Keystone House Boiler Replacement

Addendum #3: Questions and Answers

i) Keystone House

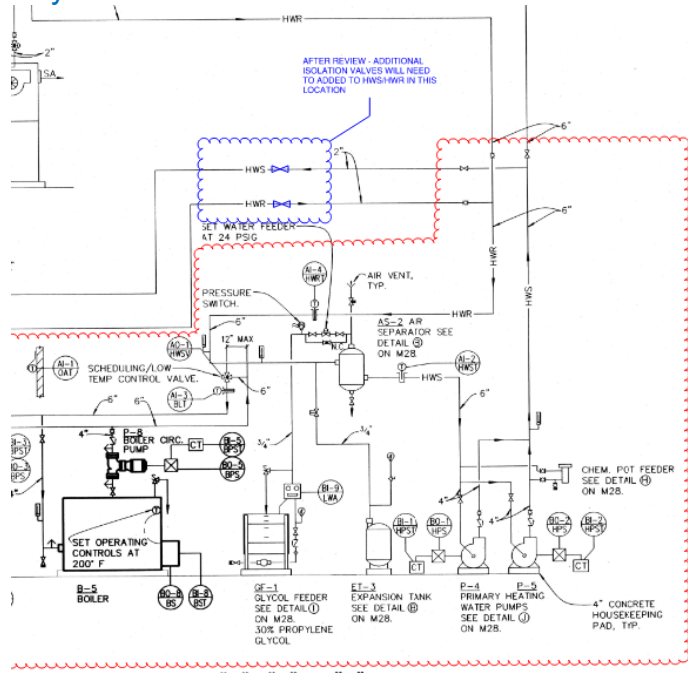
- 3) Where are the valves/scope ending? (For both jobs, but specifically the Lodge, there were not Iso valves in the Mechanical rooms)
- a) Provide valves in locations shown below.
